AGENDA

ARCHITECTURAL REVIEW BOARD MEETING

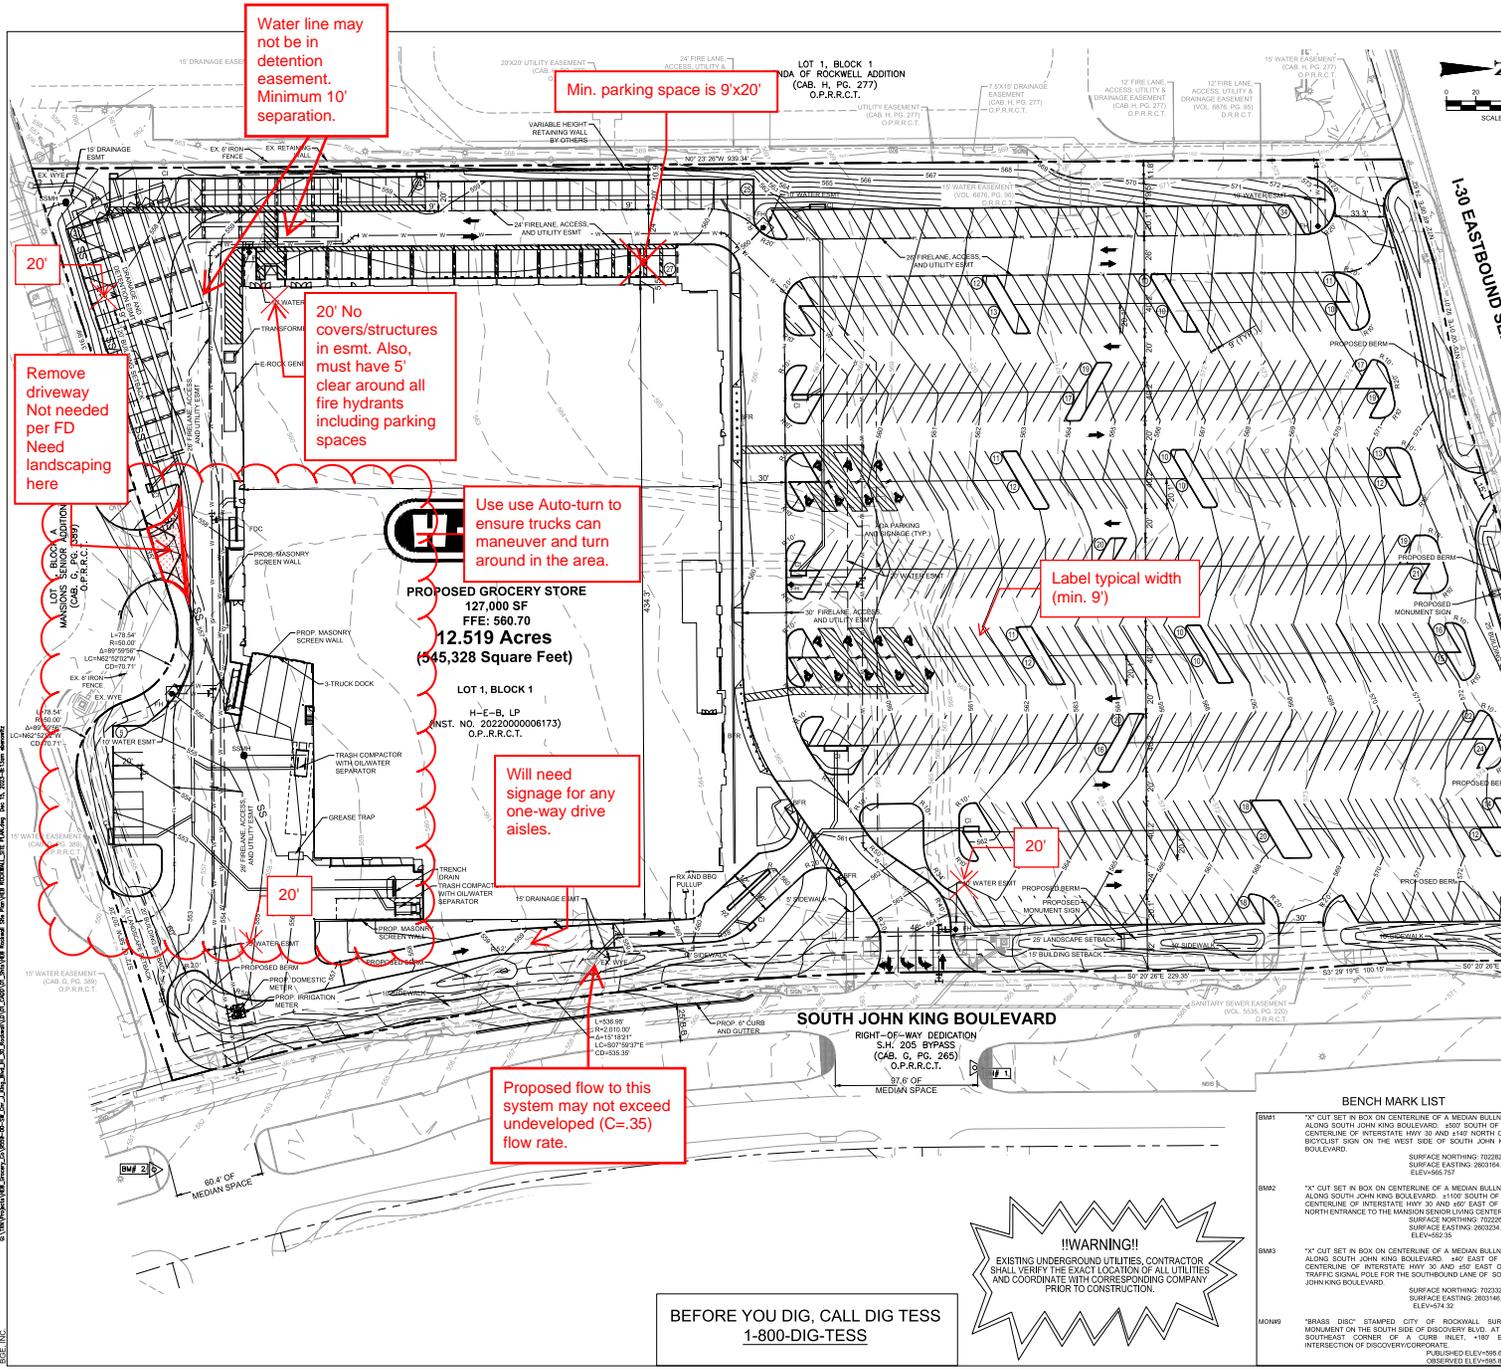
GIS COMMENTS:

PARKS DEPARTMENT COMMENTS:

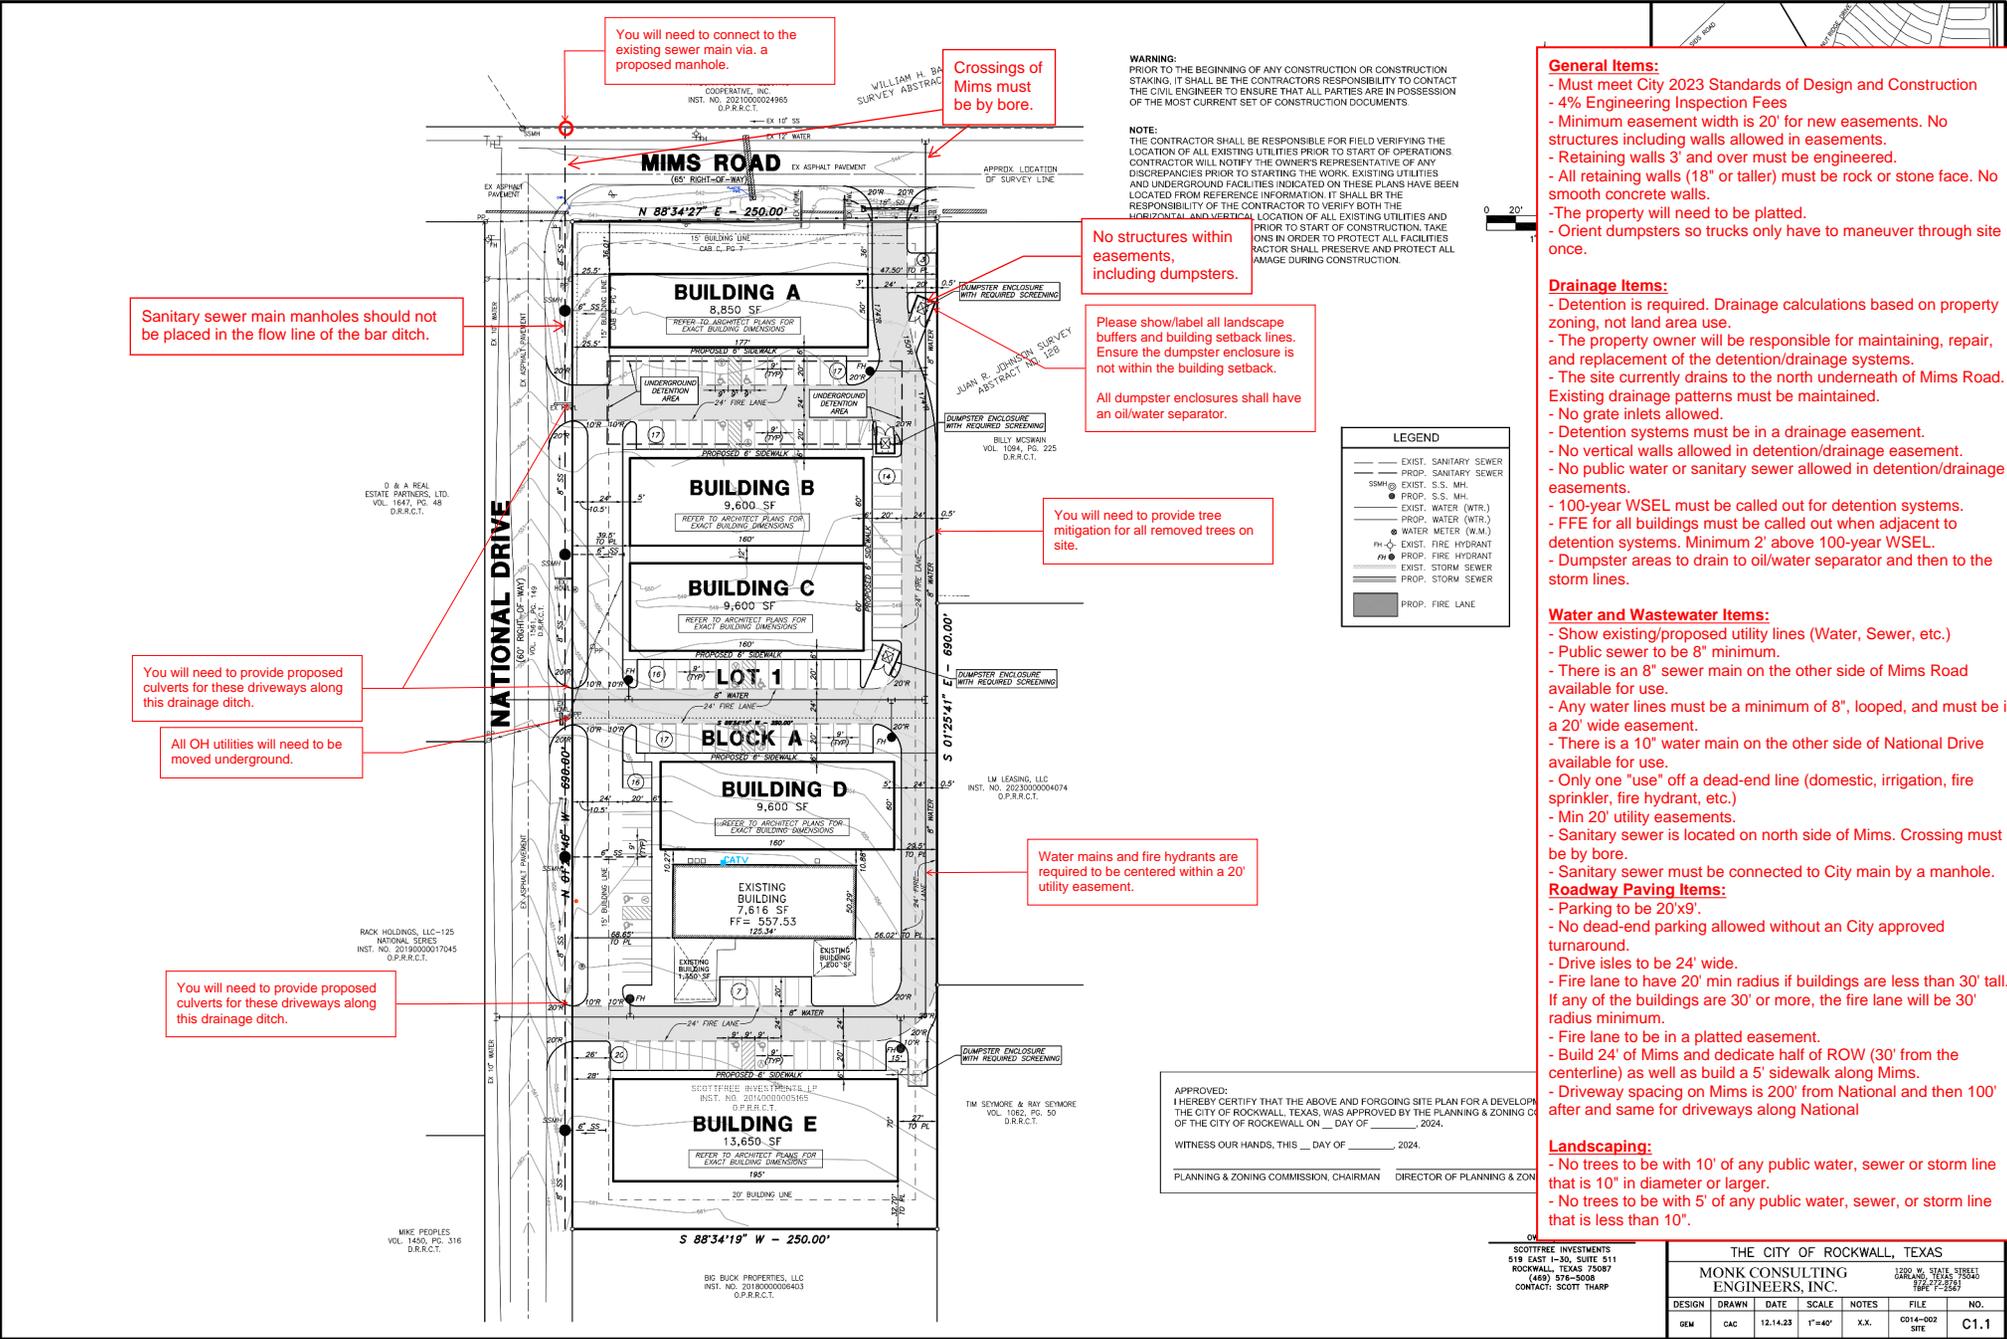
GIS COMMENTS:
